**Re: TMAC Response to Phase 2 Hope Bay Belt Project Type "A" Water License
Applications: 2AM-DOH1323 Amendment No. 2 and 2AM-BOS----; Technical Meeting
Issues and Commitments.**

Memo: Response to INAC-Rec-11: Hydrodynamic Mixing Modelling: Arsenic Predictions for Discharges to Aimaokatalok Lake. June 19, 2018

**Subject: Response to INAC-Rec-11: Hydrodynamic Mixing Modelling:
Arsenic Predictions for Discharges to Aimaokatalok Lake**

Memo: TMAC Response to INAC-Rec 2, 4, 5, 6 and 9. June 15, 2018.

**Total Arsenic Timeseries for Selected Stations,
Aimaokatalok Lake Model**

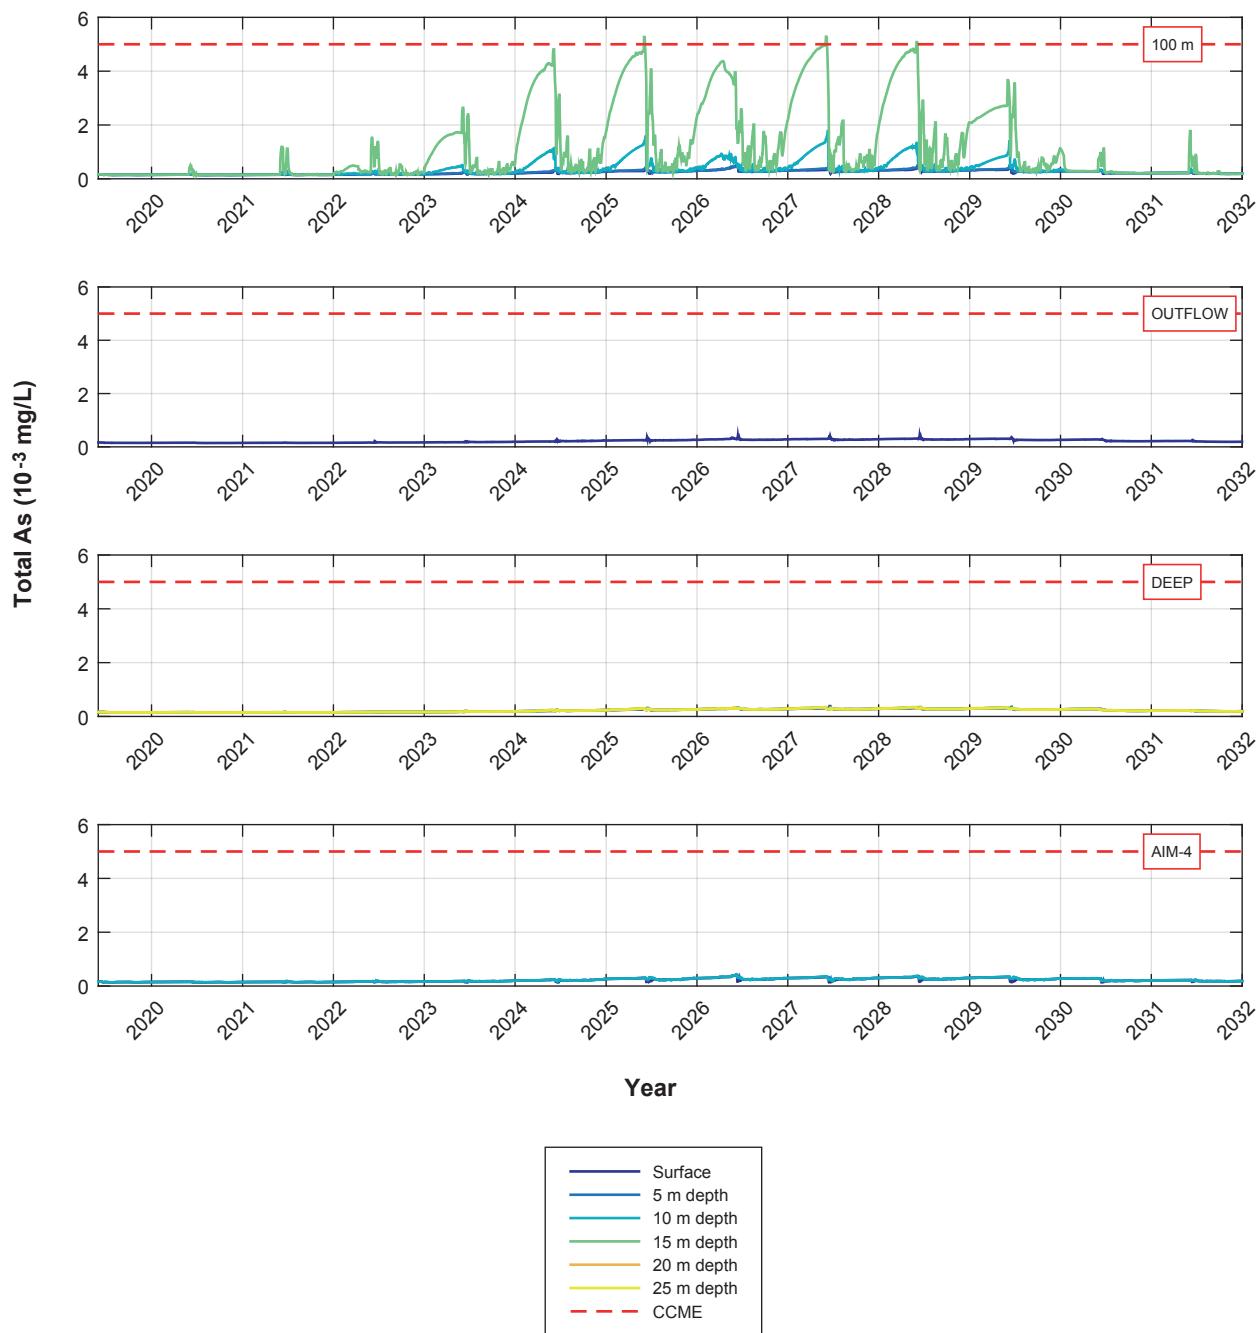
Figure 3-1 presents the predicted total arsenic concentrations with time in Aimaokatalok Lake at four locations:

All four of these areas are located either within the long western basin of the lake or nearby within the deep central basin. Similar to the phosphorus and chromium results in the FEIS modelling exercise (ERM 2017), there is very little difference in predicted arsenic concentrations among the three areas not located within the main effluent discharge trench (i.e., OUTFLOW, DEEP, and station AIM-4) as the predicted arsenic concentrations remain indistinguishable from baseline concentrations during the modeled period, and far below the CCME guideline value of 0.005 mg/L.

Total Arsenic Average Predictions for
Aimaokatalok Lake: May and August 2028

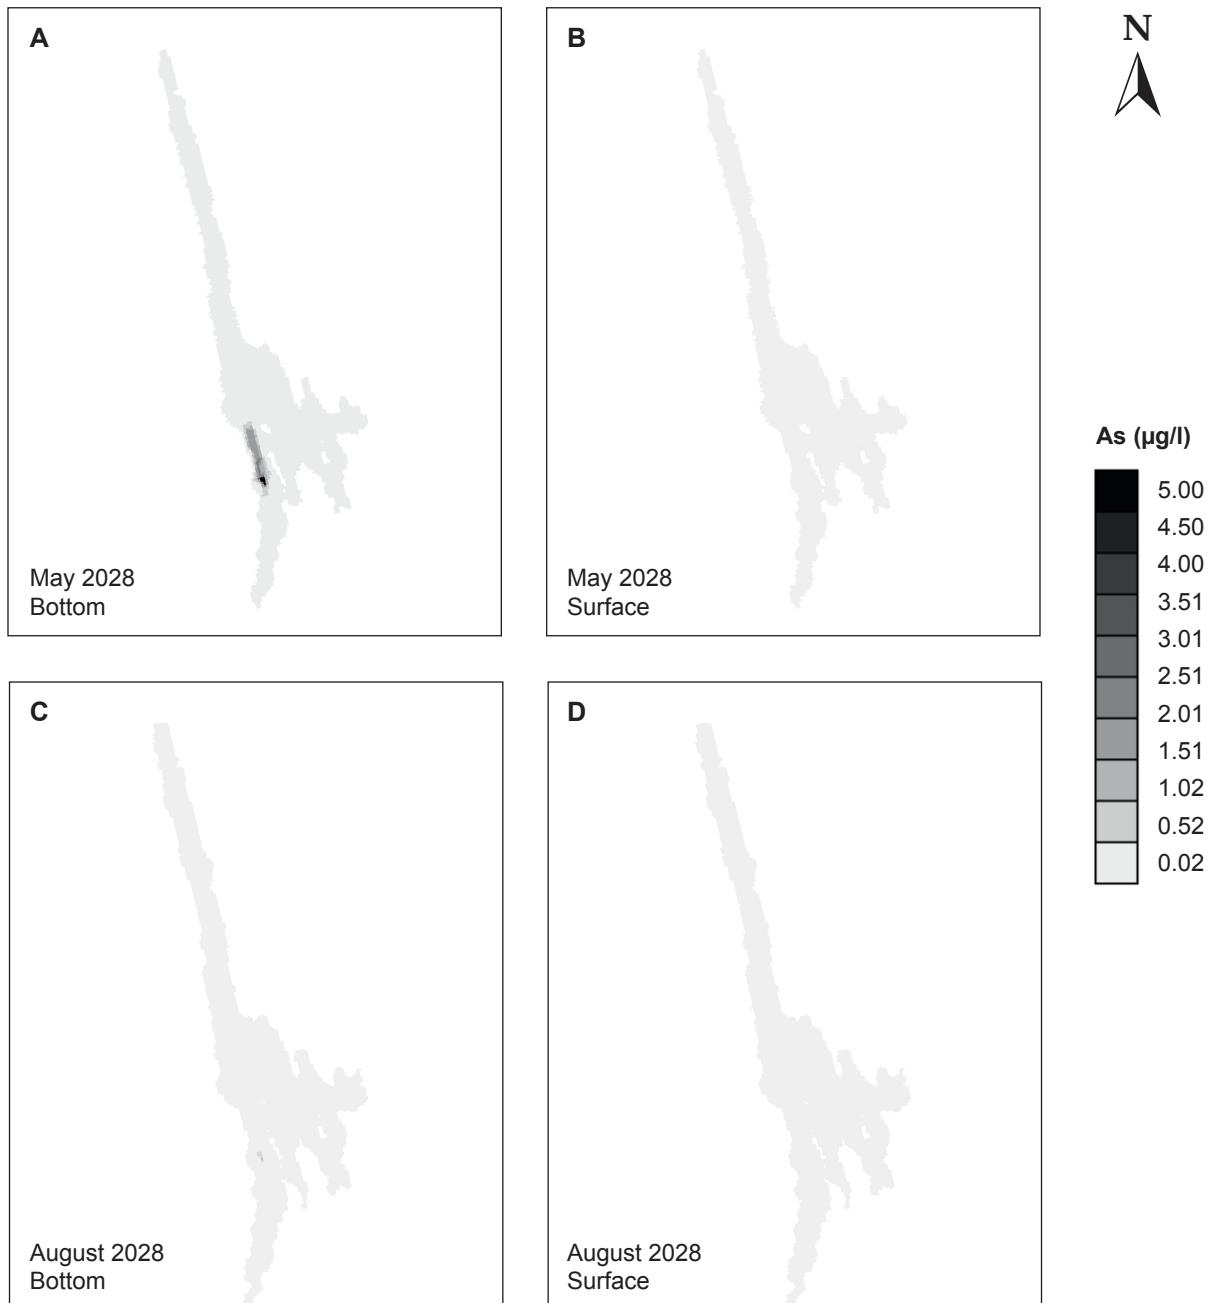
The contour heat plots shown in Figure 3-2 represent average bottom and surface water arsenic concentrations throughout Aimaokatalok Lake for the May and August 2028 simulations (last year of maximum discharge concentrations; Figure 2-2). August results show that the vast majority of the lake area maintains arsenic concentrations near baseline concentrations (below 0.0002 mg/L) during the open-water season, with increased concentrations only present in the immediate near-field mixing area of the Boston WTP-STP combined discharge location. May under-ice concentrations in the bottom waters were more variable, with a peak at the outfall location and greater concentrations found within the deeper trench in the western section of the lake. This demarcation is not apparent in the under-ice surface waters and quickly dissipates once currents mix lake waters in the open-water season.

In summary, arsenic concentrations are predicted be near baseline levels throughout Aimaokatalok Lake during the operational phase of the Project when WTP discharge is treated to the conservative concentration of 0.1 mg/L, and therefore protective of aquatic life. The exception is within the small, bottom water mixing zone within 100 m of the outfall during the under-ice season. Within this zone, arsenic concentrations are predicted to approach the CCME arsenic guideline concentration of 0.005 mg/L at the 100 m perimeter near the end of the ice-covered season. Arsenic concentrations may be temporarily greater than the CCME threshold near the effluent outfall due to the sharp June increase in effluent discharge flow, but will decrease rapidly with the onset of freshet.

The higher arsenic concentrations within the under-ice, bottom water mixing zone are not expected to affect aquatic life since they are near the CCME guideline of 0.005 mg/L and far below the 0.025 mg/L arsenic site-specific water quality objective determined to be protective of the similar Arctic aquatic habitat for the Back River Project in Nunavut. As well, the arsenic CCME guideline of 0.005 mg/L has a 10-fold safety factor applied (CCME 2018), and the most sensitive species used to derive the guideline was affected at 0.05 mg/L of arsenic, which is half that conservatively predicted in the effluent. This concentration would be met in the Aimaokatalok Lake receiving environment almost immediately based on dilutions modelled previously (ERM 2016). Given the conservative 0.1 mg/L arsenic WTP concentration and the short duration that arsenic concentrations are predicted to be near the CCME guideline in the near-field receiving environment, there are no effects predicted for the aquatic life in Aimaokatalok Lake. Potential environmental effects in the lake will be assessed through the Environment Effects Monitoring program of the MDMER and the Boston-Madrid Aquatic Effects Monitoring Program (AEMP). If effects are found in the lake, they will be adaptively managed through the Aquatic Response Framework built into the AEMP.
